STAFF RECOMMENDATION
1011 Chicamauga Avenue
December 21, 2016

Application: New construction – infill; Outbuilding; Setback determination

District: Greenwood Neighborhood Conservation Zoning Overlay

Description of Project: The applicant proposes to add onto an existing non-contributing structure to the extent that staff reviews it as a new structure. An outbuilding is also proposed, with a setback determination requested for the rear, from twenty feet (20') to seven feet (7').

Figure 2. Front elevation proposed

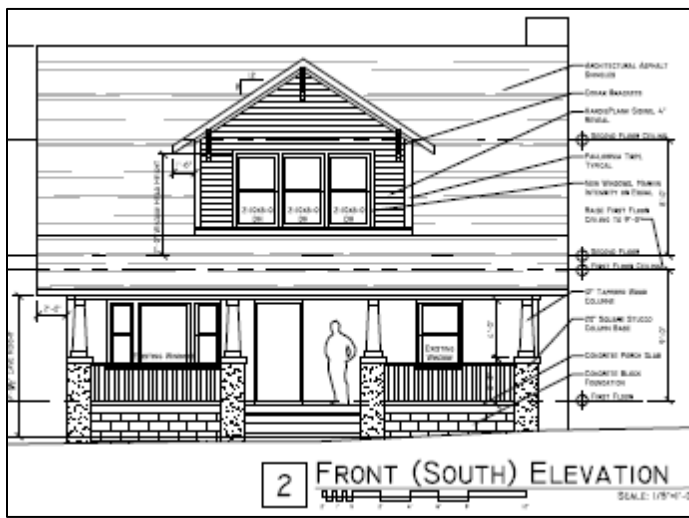
Height & Scale: The proposed new home is one-and-a-half stories with an overall height of twenty-seven feet (27’) from grade. The new structure is maintaining the existing foundation height, approximately two feet (2’). The eave height will be nine feet, eight inches (9’ 8”) from grade, also the same as the existing eave height. The home to the left is non-contributing and so not used for context and the home to the right is approximately

The footprint will be increased from nine hundred sixty-two square feet (962 sq. ft.) to one thousand, eight hundred and eighty-seven square feet (1,887 sq. ft.), including the new front porch and rear screened porch. Staff finds that the new structure's height and scale are compatible with the context, and meet section II.B.1.a. and b.

Roof form: The new roof form will be side-gabled with a pitch of 8/12. A front-gabled dormer has the same pitch. The front dormer sits at two feet (2') from the wall beneath it. A shed dormer will be added to the rear roof plane. A new exterior-side chimney will be added to the building's right side. Staff finds that the roof form of the proposed new structure meets section II.B.1.e.

Proportion and Rhythm of Openings: The existing front window dimensions will be retained; however the shutters will be removed. New window openings on the proposed structure are generally twice as tall as they are wide, meeting the historic proportions of openings. There are no large expanses of wall space without a window or door opening. Staff finds the project’s proportion and rhythm of openings to meet Section II.B.1.g.
